## **Authors' comment**

Thank you for your insightful feedback. In this document, you will find the answers to your questions and comments, and a description of what will be modified in the revised manuscript.

To improve the soundness of the assessment of the setup, which is the core of the work, the revised manuscript will include additional analyses, with a more thorough verification of the aerodynamic force estimation and additional comparisons between the floater numerical model and the benchmark.

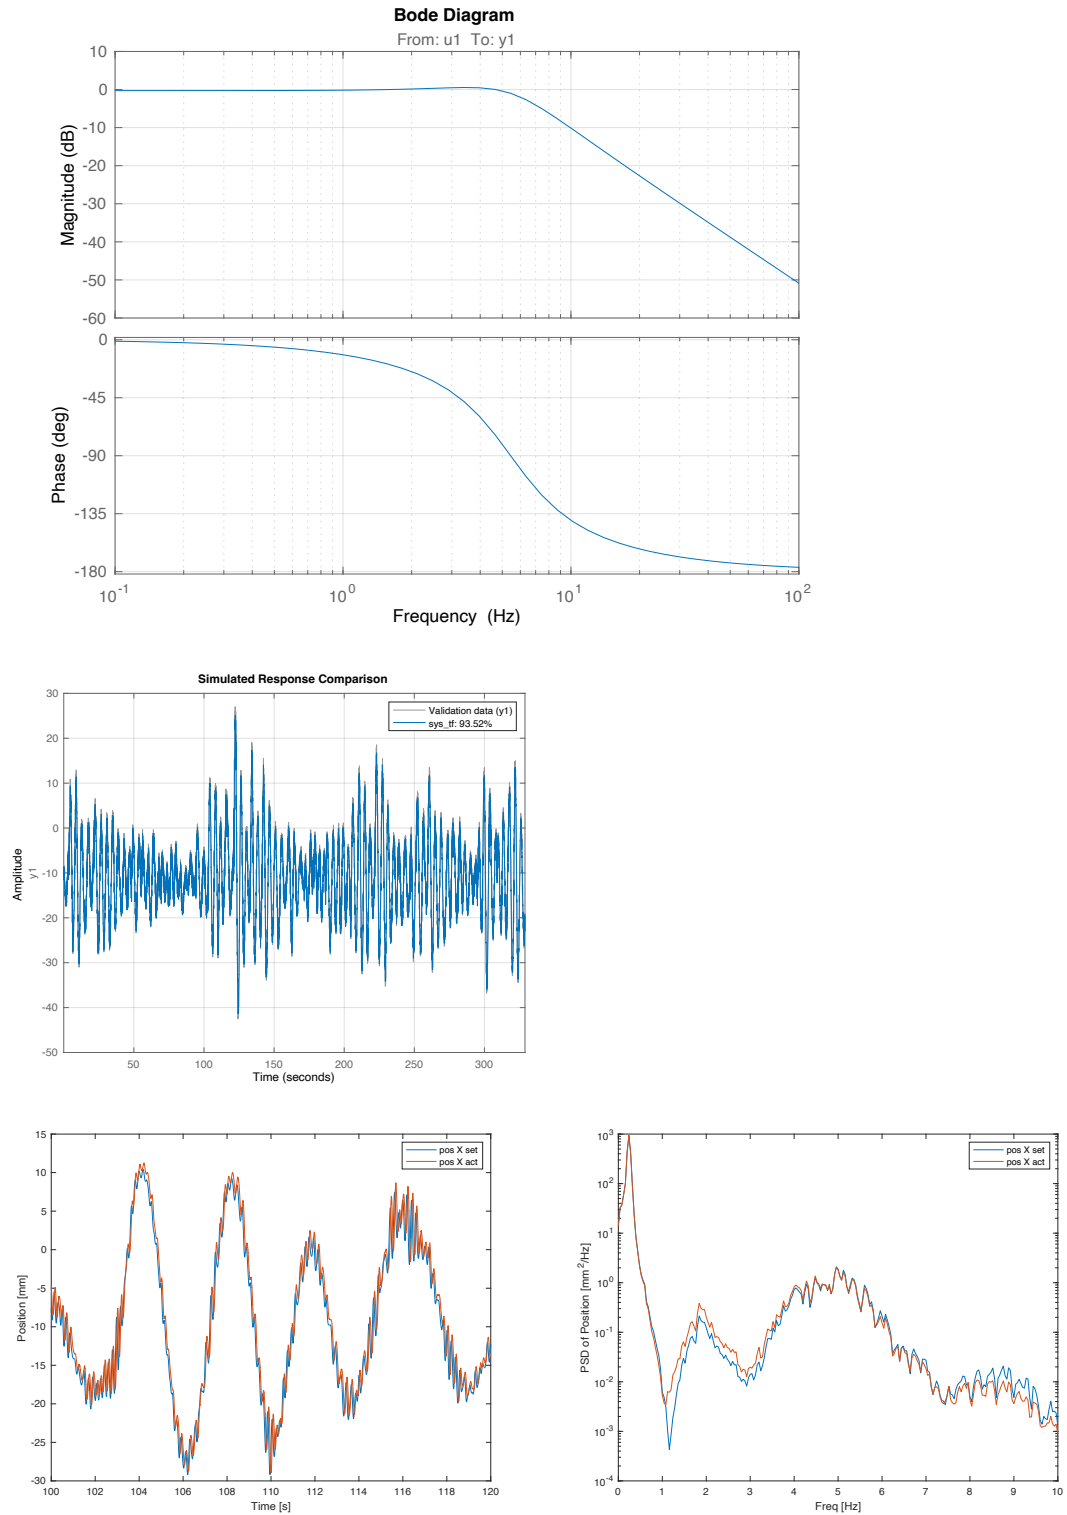
- L141: “NREL 5MW ... to the scale”. Add reference documents for the two wind turbine designs and be more accurate on what you mean with adjusting the operating parameters (rated wind speed, working TSR) and why this is acceptable (e.g. the optimal TSR of the IEA 15MW is different from the one of the DTU 10MW, thus if you run your rotor at the TSR of the IEA 15MW the local angle of attack is suboptimal for the rotor design).

We agree with the observation. We preliminary did a OpenFAST analysis of our scale model, and we reproduced the 15MW thrust curve with about 5% error at rated with respect to the OpenFAST of the 15MW, which could be consider acceptable. This has not yet been tested experimentally. However, the text will be modified, stating that it is possible to use the turbine to reproduce different rotor ratings, without specifying the IEA 15MW or NREL 5MW.

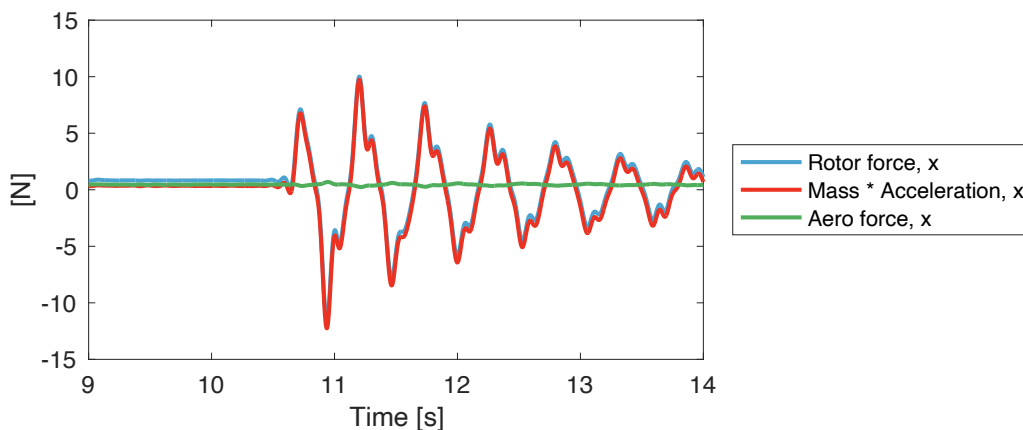
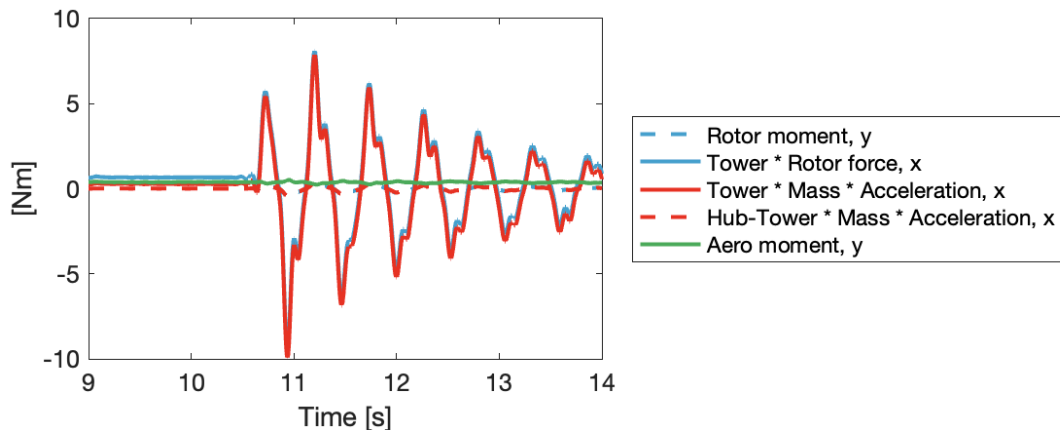
- Section 3: Which is the delay in the measurement-actuation chain? Where it mostly comes from? (e.g. the hexapod motion controller). Which is the transfer function between motion setpoint and actual motion of the hexapod?

- L215-216: “de-synchronization of signals ... acceleration inputs”. I think the authors must explain more clearly why they didn't use filters. I suspect the first bending frequencies of the scale model (tower and blade FW) could be at around 10 Hz. The forces resulting from the vibrations of the scale model components are measured by the load and are transferred to the numerical model of the platform causing it to respond at the same frequency of the flexible vibrations. This normally gives rise to a loop that could make the HIL system unstable. Why it's not the case? Is it related to the motion tracking performance of the hexapod which maybe filters out and does not track motions at high frequency. I ask the author to provide the transfer function (in a plot or also by means of values at some frequencies reported in the text) of the hexapod setpoint-->actual movement in terms of magnitude and phase.

An estimation of the delay is given in Section 3.3.3. The Bode diagram between the position setpoint and actual position (of surge DOF) evaluated for the wind and wave case in Figure 9 of the preprint is reported here (the transfer function is estimated with 2 poles to represent the mechanical system, and the fit is reported after). The time history (cut) and PSD of the signals are also reported below. A time history showing setpoint and actual position and the Bode diagram will be included in the manuscript in the section about the hexapod.

It was decided not to use filters because all the filters and cutoff frequencies tested during the calibration of the system resulted in an unstable HIL system. Indeed, the first tower frequency is 12.5Hz, and the first blade (flapwise) frequency is around 16Hz. What most likely filters out the higher frequencies is the floater dynamic system model in combination with the motion tracking of the hexapod. The Bode plot of the Hexapod is shown above.

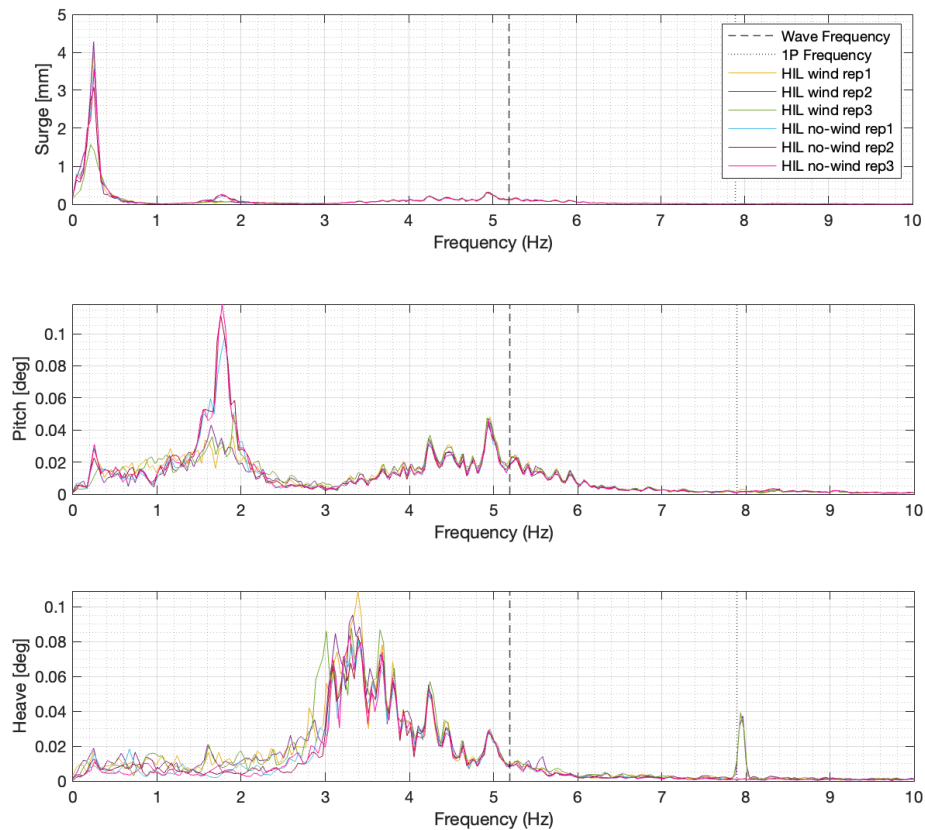
- L350: "this is also the region where the effects on wind are visible". The figure only shows the response with wind but not the case of waves without wind (like in Fig. 7-8) so it's impossible to tell at which frequencies the aerodynamic loads have a meaningful effect. Unfortunately, no wave case in no-wind conditions was performed in that wind tunnel campaign, and so no comparison can be shown in the manuscript. However, it is known that the wind effects are in the low-frequency region. Although not suitable to be included in the paper (reasons follow), here we can show the comparison between HIL (closed loop) wave cases in wind and no-wind conditions preliminary tested in a previous campaign (unpublished). The floater concept is still the TripleSpar and also the sea state (Hs 3.04, Tp 9.5), but the floater dynamic model has few differences with the current one, and the HIL runs at 3 DOF only. The most visible effect is that the cases with wind and rotor operating have a lower peak at the pitch natural frequency for pitch DOF. However, to give the article a different cut and concentrate on the development of the HIL, it was decided not to deepen this analysis in the study. Future studies will focus

on the aerodynamic effect on FOWT dynamics making use of the setup.

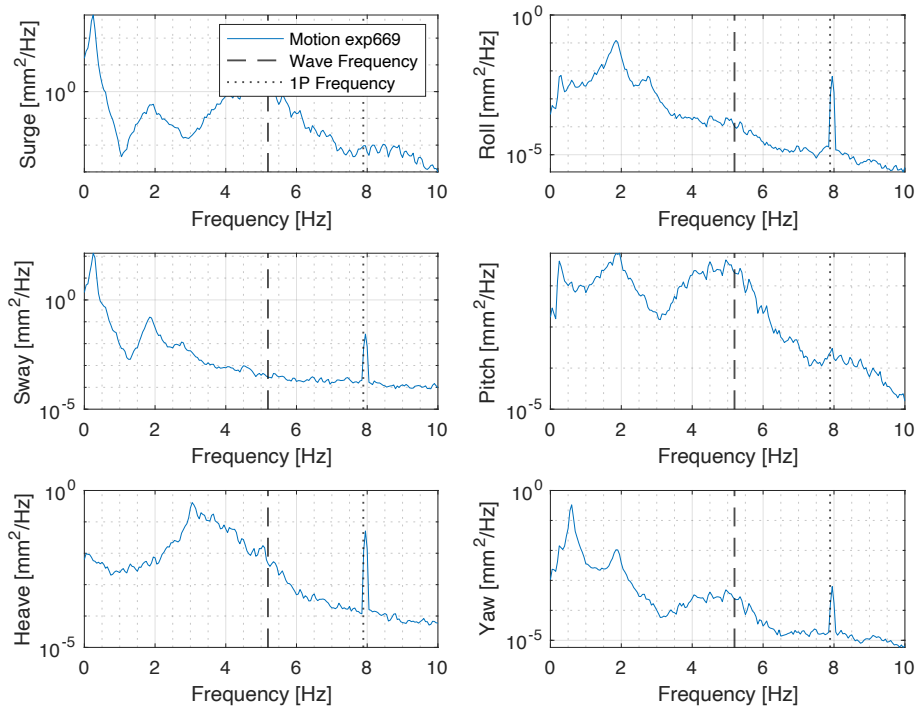
- Figure 9: Can you do some averaging when computing spectra (e.g., with Pwelch), otherwise it's difficult to identify the features of the spectra.

The figure will be changed with spectra computed with Welch's method:
